75W MODIFICATION TO APPLICATION TO  
BARANGAROO CONCEPT PLAN (MP06\_0162 MOD 8)

## MOD 8 DRAFT CONDITIONS | PART B – MODIFICATIONS TO CONCEPT PLAN **RESPONSE TO CONDITION B3**

16 FEBRUARY 2016

PROPOSED AMENDMENT

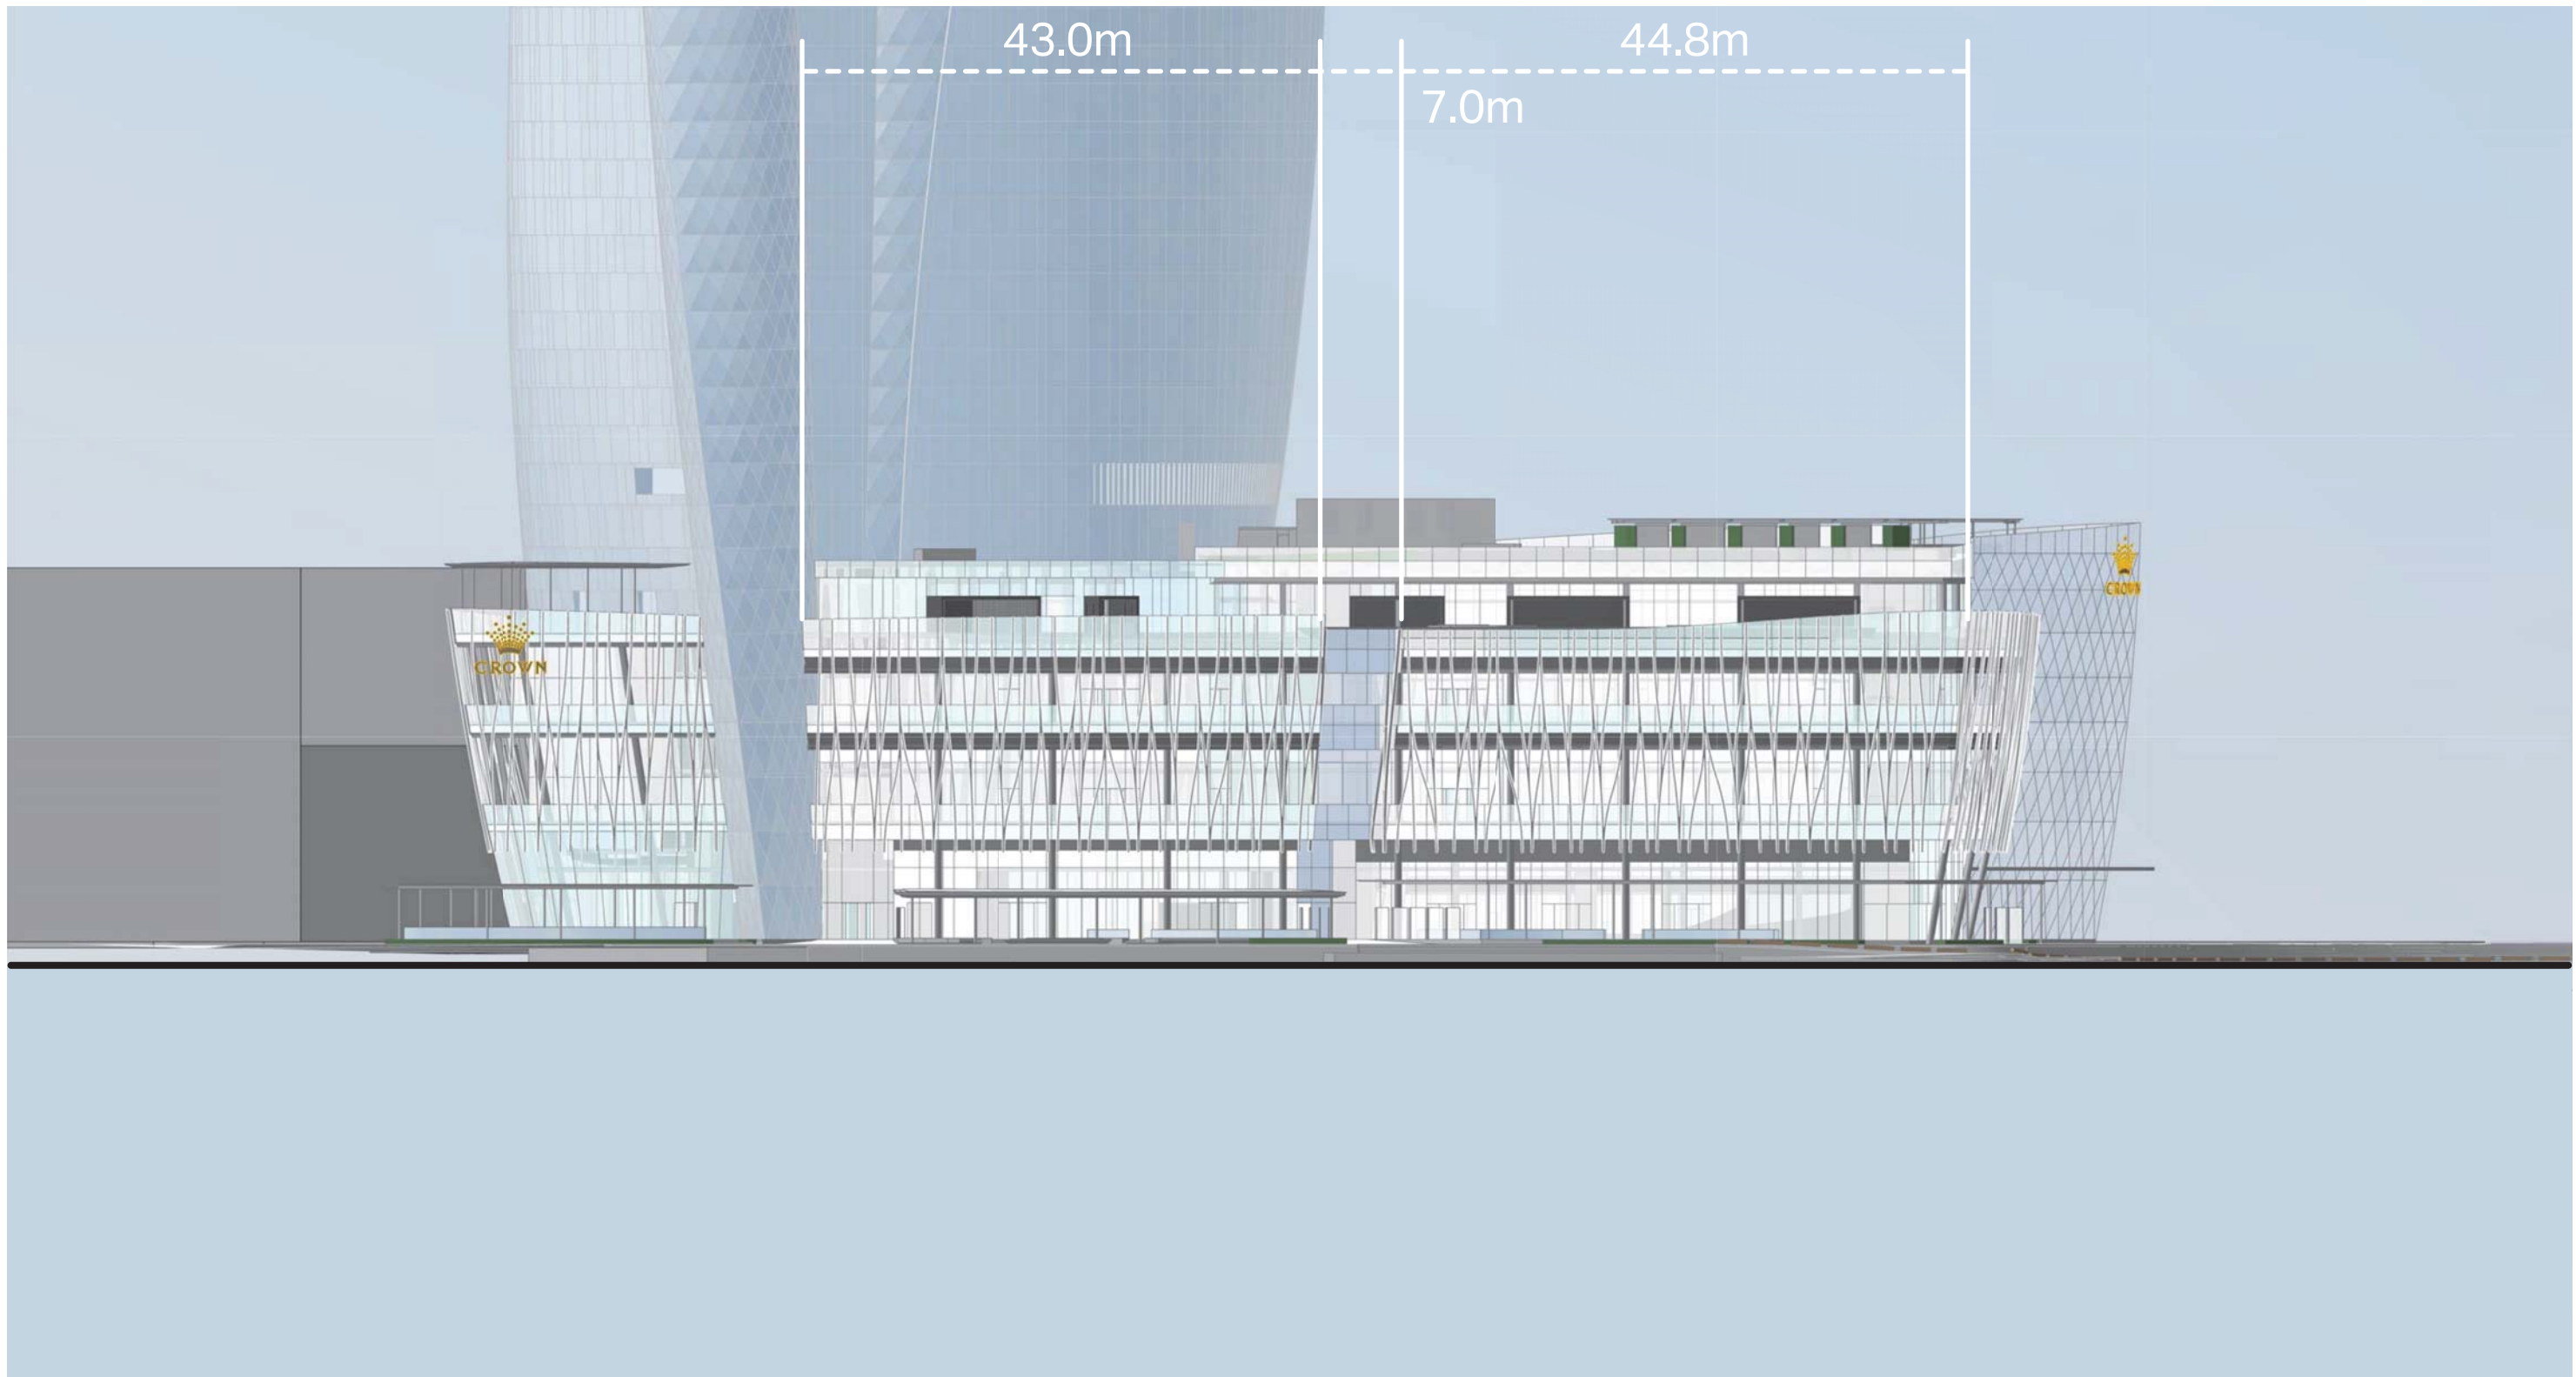
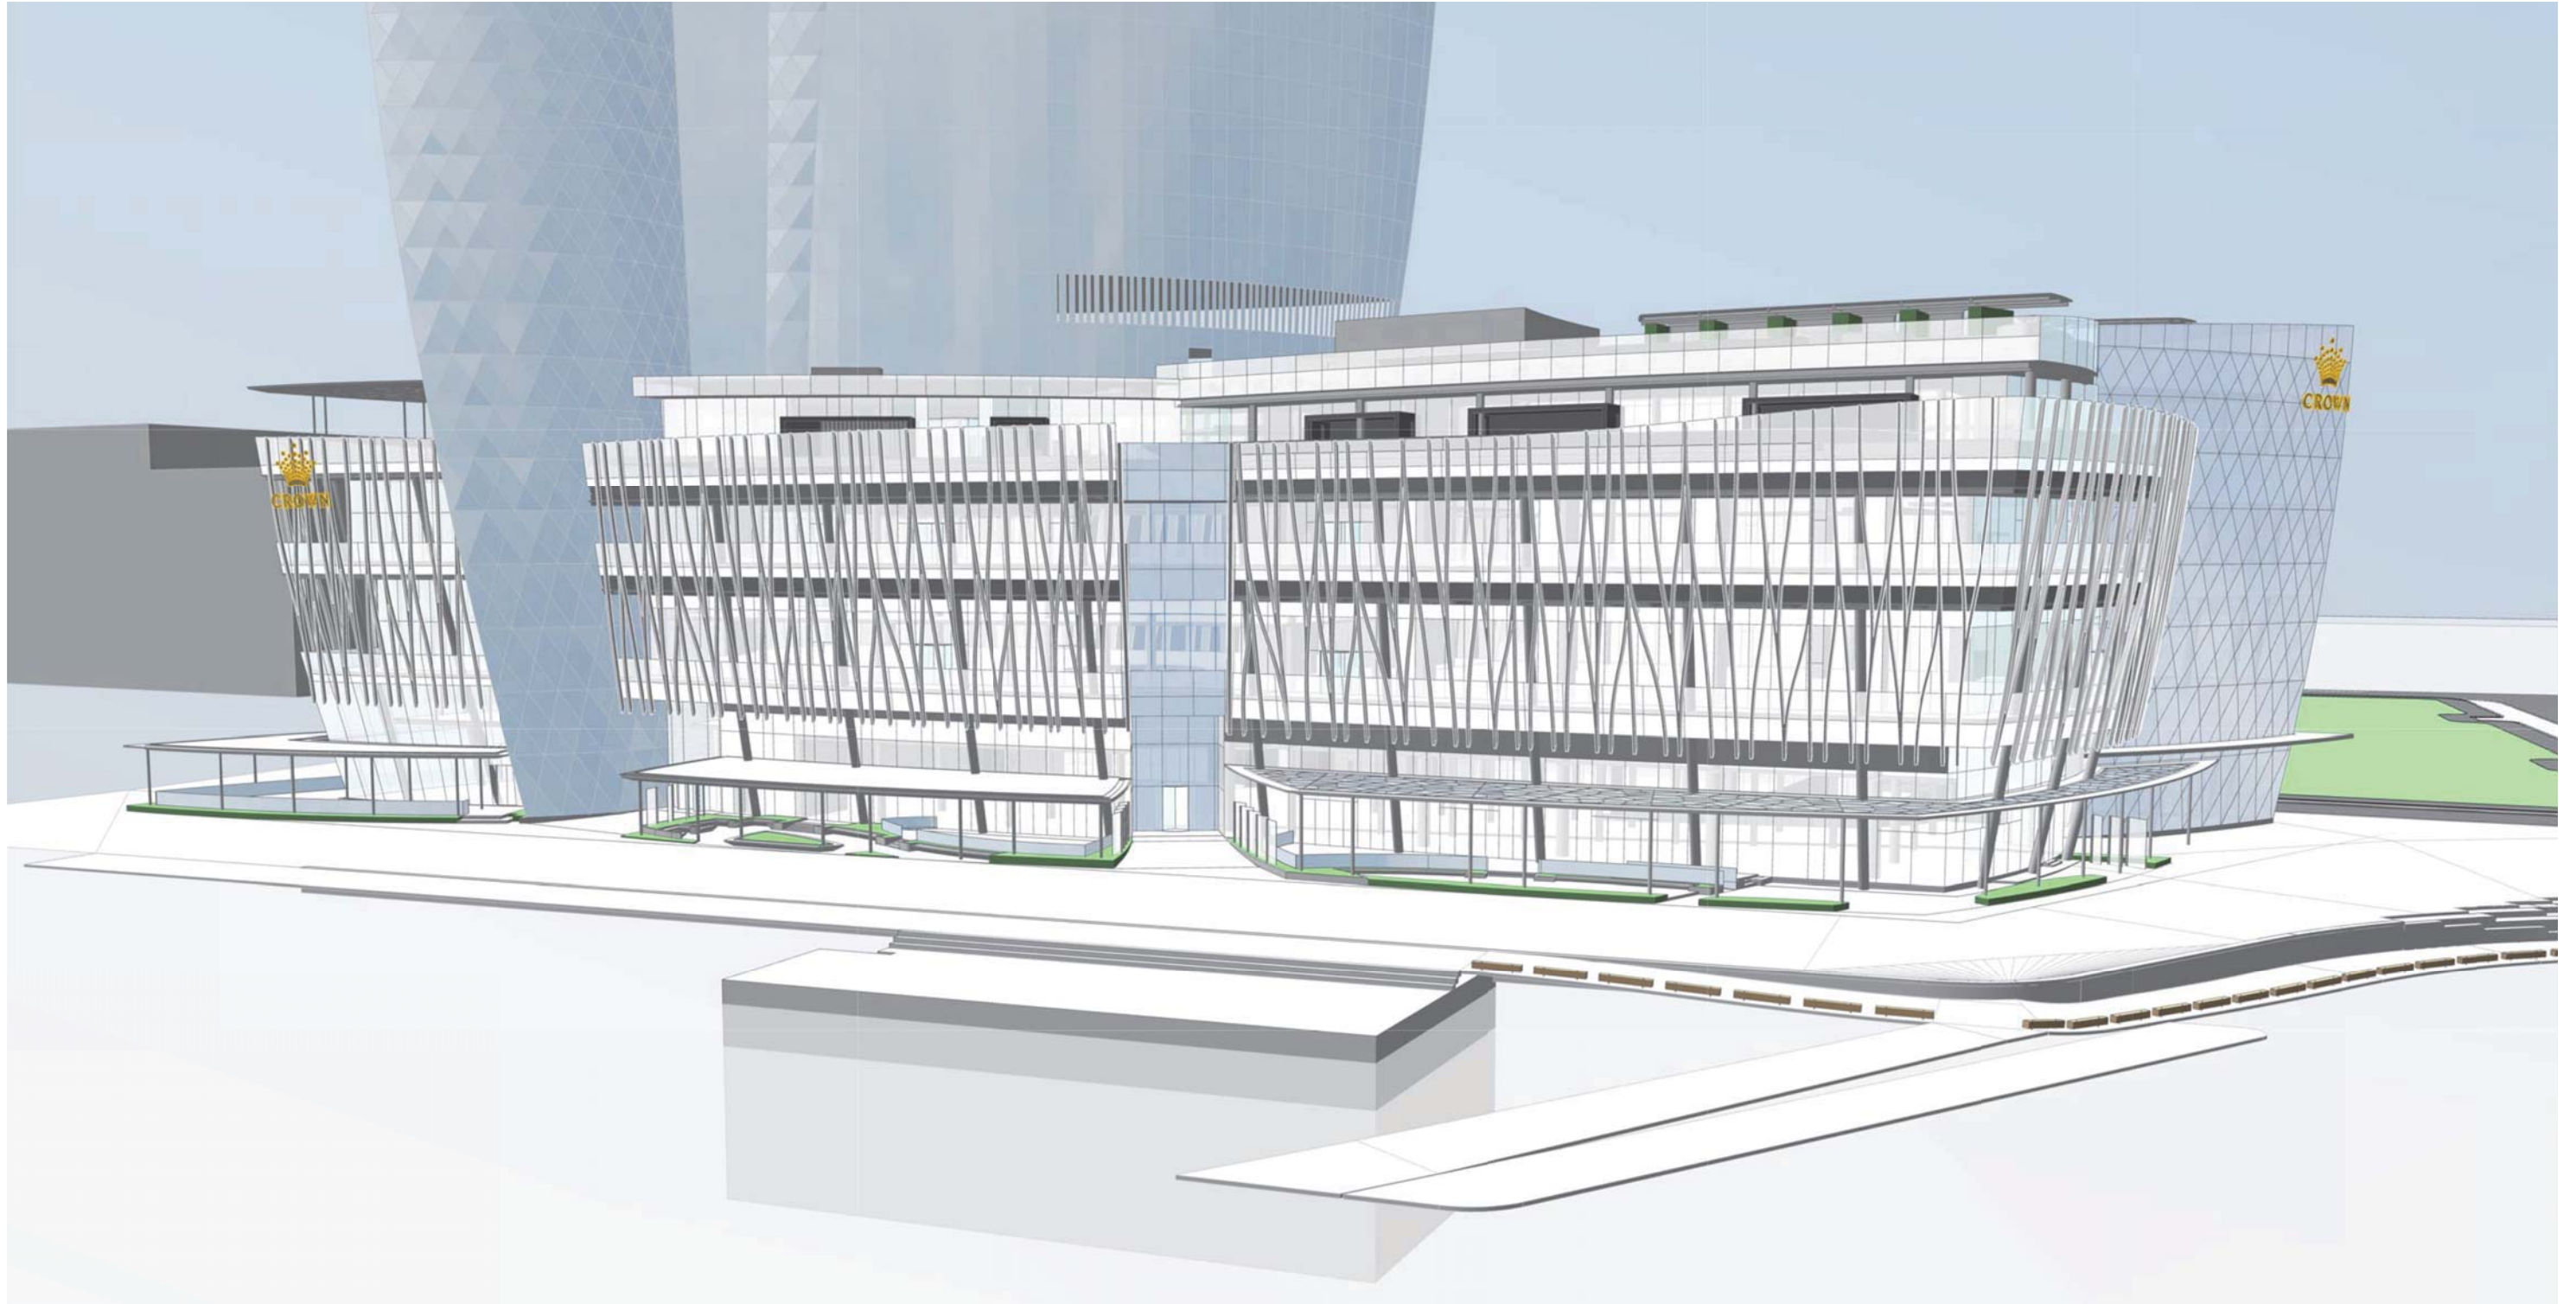
As illustrated within the attached plans, the westerly facade of the CSHR podium has been re-designed in order to break the podium structure up into distinct building elements that are now viewed as a segmented building in lieu of a continuous built form.

By re-designing the podium facades in this manner, the overall perceived length of the façade is significantly reduced when viewed from the surrounding Public Domain and from across the harbour.

The stated objective of reducing the excessive length, bulk and scale of the podium is to ensure a more appropriate relationship to its foreshore context has, in our opinion, been achieved as the podium will no longer be viewed as a continuous, unbroken built form.

*East Elevation*

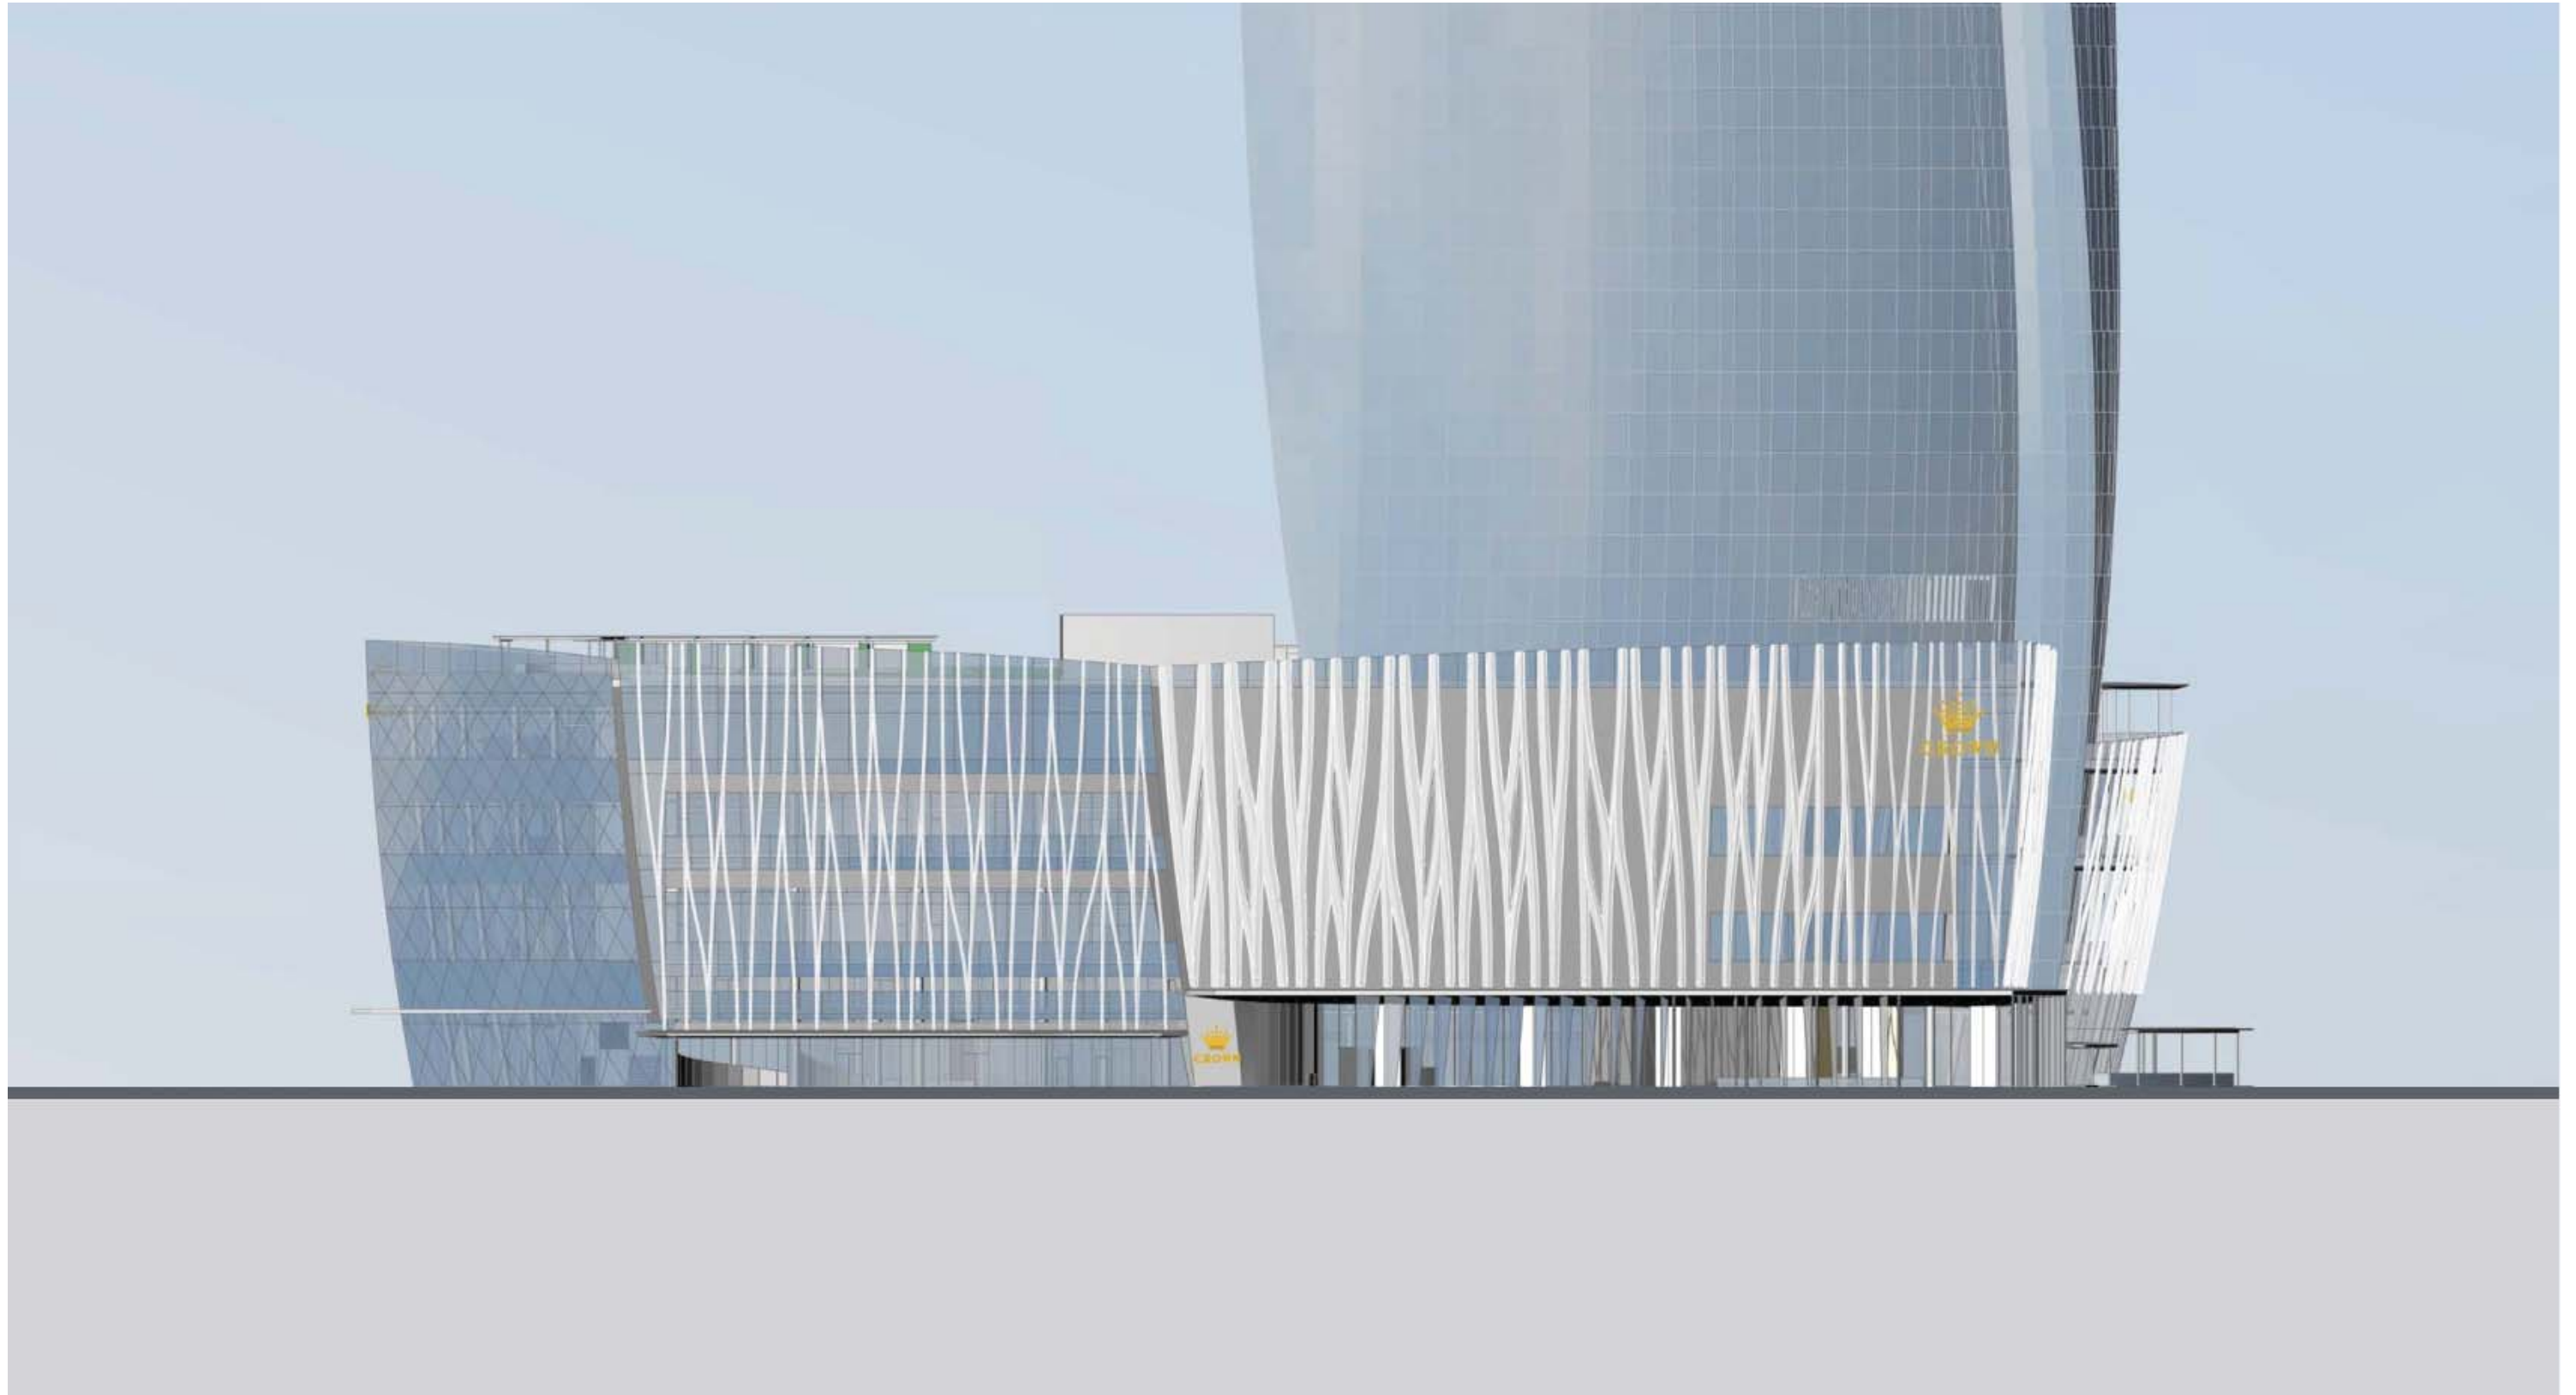
The eastern podium elevation, whilst not mentioned in the B3 draft condition, is currently being re-designed in order to achieve a coherent and consistent design approach around all sides of the podium.
